# Strengthening the National Framework for Climate Transparency of Panama

**Review CEO Endorsement and Make a recommendation**

11497 Countries

Strengthening the National Framework for Climate Transparency of Panama Agencies

#### iii. National reporting to the United Nations Framework Convention on Climate Change

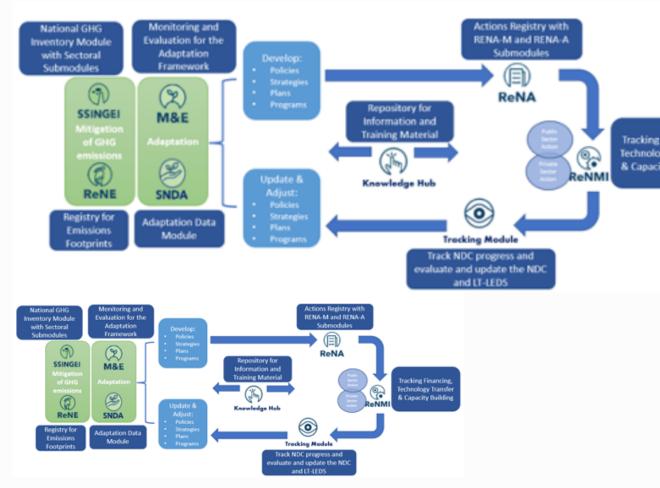
1. The highlighted text seems to be incomplete. Should it be replaced by "The third NC"? If so, please amend.

1. The text was amended according to suggestion (the third NC)

## TABLE 6. DESIRED TRANSFORMATION AS A RESULT OF THIS PROJECT'S IMPLEMENTATION

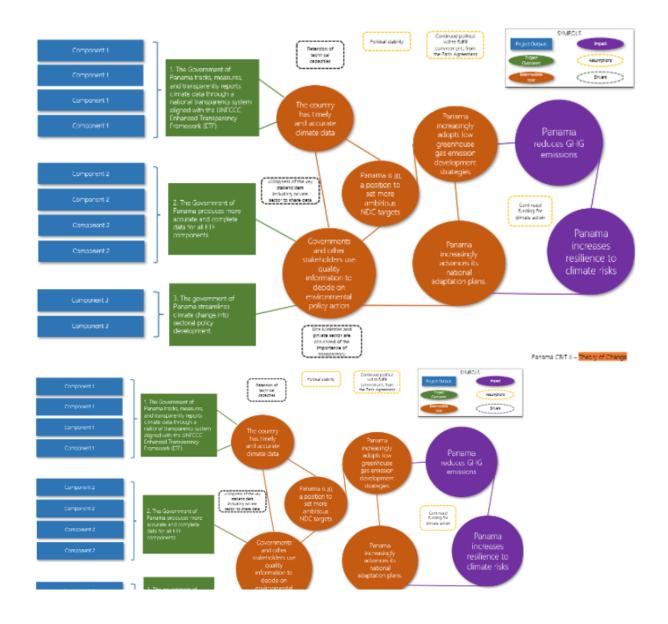
1. There seems to be a reference error in the text above Table 6; please correct it.

- 1. Reference error in the text above Table 6 was corrected.
- 2. Theory of Change figure was adjusted to be reflected only once.
- 3. Regarding Table 7,
- 3.1 Modules mentioned in Table 3 are aligned to Table 7.
- 3.2 Tale 7 columns Layout adjusted
